# CASCADE CHARTER TOWNSHIP

**AGENDA**  
**Cascade Charter Township Planning Commission**  
**Monday, May 18, 2020**  
**7:00 pm**  
**Cascade Library Wisner Center**  
**2870 Jacksmith Ave. SE**

TO: Cascade Charter Township Planning Commission  
FROM: Steve Peterson, Community Development Director  
REPORT DATE: May 13, 2020  
MEETING DATE: May 18, 2020  
CASE: #19-3527/Roundhill PUD Amendments – Sentinel Pointe

### **Round Hill, 3000 Thornhills Avenue Site Plan Review**

**SHEET NO:**  
**Propo**

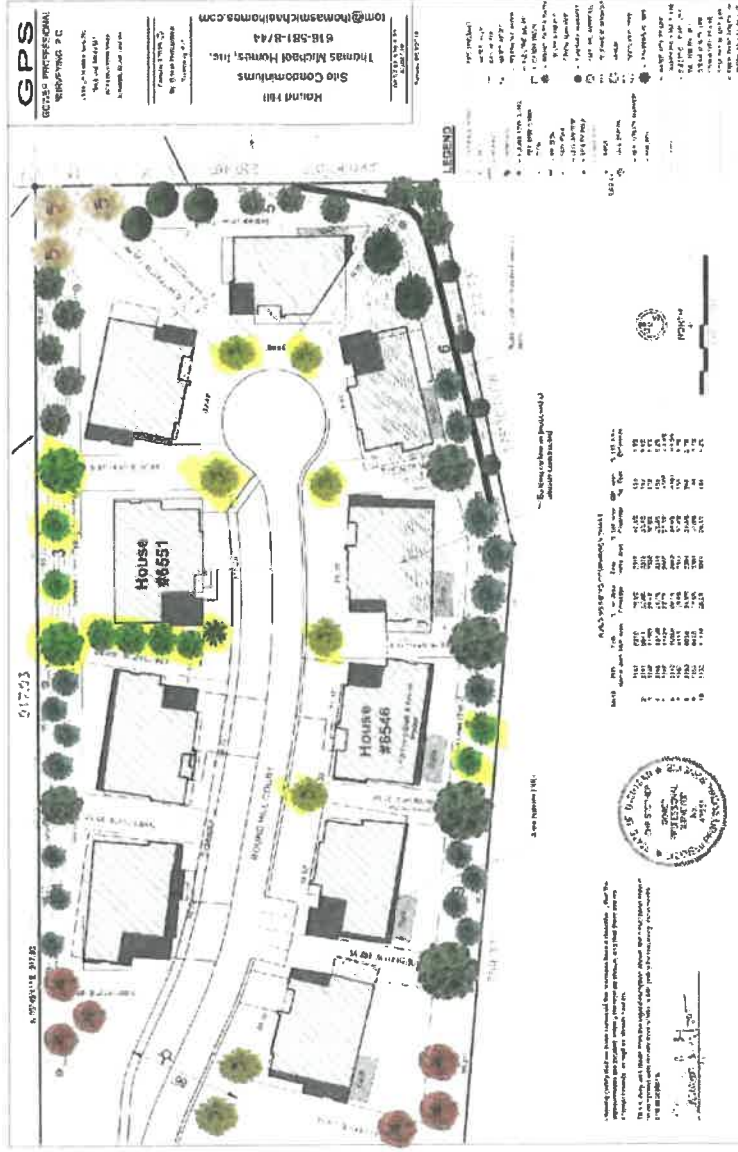
The current retention basin was not constructed according the 2015 approved plan. Upon inspection, the slopes were steeper than 1:3, the overflow spillway erosion mat was not in place and the restoration was non-existent. The original 2015 site plan required a maximum of 1:3 slopes to allow the basin to be maintained. The developer has redesigned the basin to include the 1:3 slopes with a 1:3 route down to the basin for maintenance purposes. The developer revised the calculations for the new layout of the basin. Those calculations were reviewed and are acceptable. The April 10, 2020 site plan includes a note about how the bottom of the basin should be roughened and left uncompacted. The Maintenance route is also identified on the current site plan. This addresses two items we identified during our December 2019 review.

The storm sewer between MH 101 and Flared End Section 100 was placed with a steeper slope than on the original 2015 site plan resulting in higher velocities than expected. Those high velocities have the potential for increased erosion at the outlet which will require future maintenance. The April 10, 2020 site plan includes an outlet detail identifying the rip rap pad dimensions, depth and minimum stone size. This addresses the outlet erosion item we identified in our December 2019 review letter.

The revised plan includes details for the overflow spillway for the retention basin. It should be noted the basin is designed for the 100-year rain event and if functioning properly the spillway would only be needed in the rare 100-year or larger event. The developer proposed a permanent turf reinforcement mat with riprap at the bottom of the slope. This design was acceptable on the December 2019 site plan and has not been changed. We are comfortable with their approach provided the details are followed during construction.

Sheet  
 1 of 2

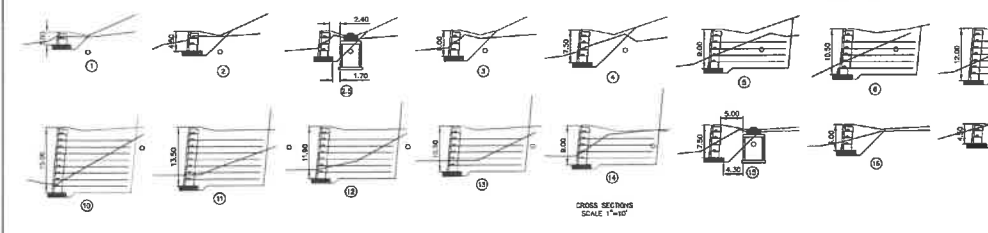
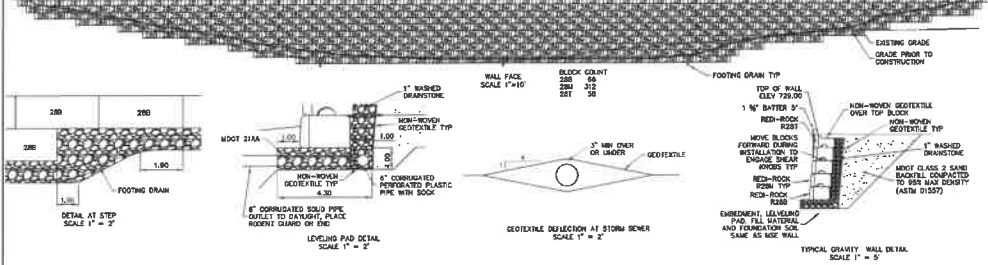
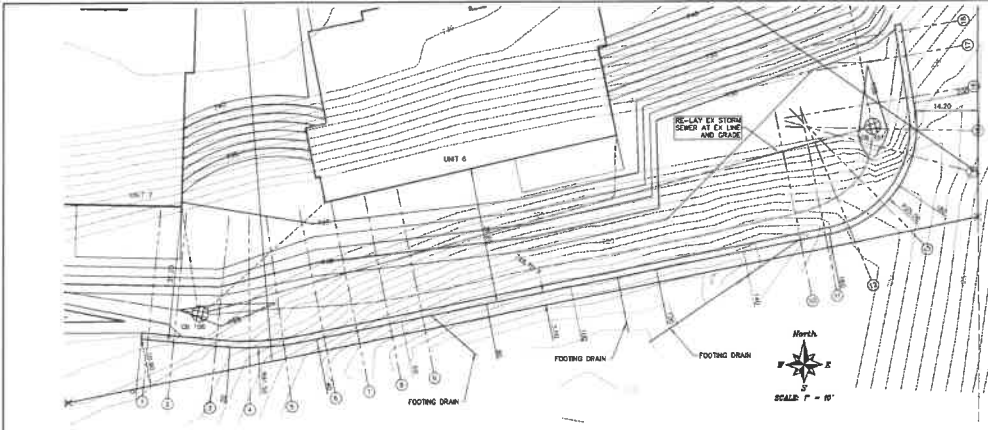
The revised site plan shows a Redi-Rock concrete block retaining wall for the entire length of Lot 6 and extending partially on to Lots 5 and 7. There is a swale graded behind the wall (Best shown on the cross sections of the wall plan) that is designed to capture the runoff from this area and direct it to the retention basin.)

The retaining wall design has been reviewed for the Township by MTC and their review letter is being provided. There were a number of iterations of this design and additional information that MTC required for their review. With MTC being satisfied with the design of the wall we are also satisfied. However, it is critical that the wall be built according to the approved plan.
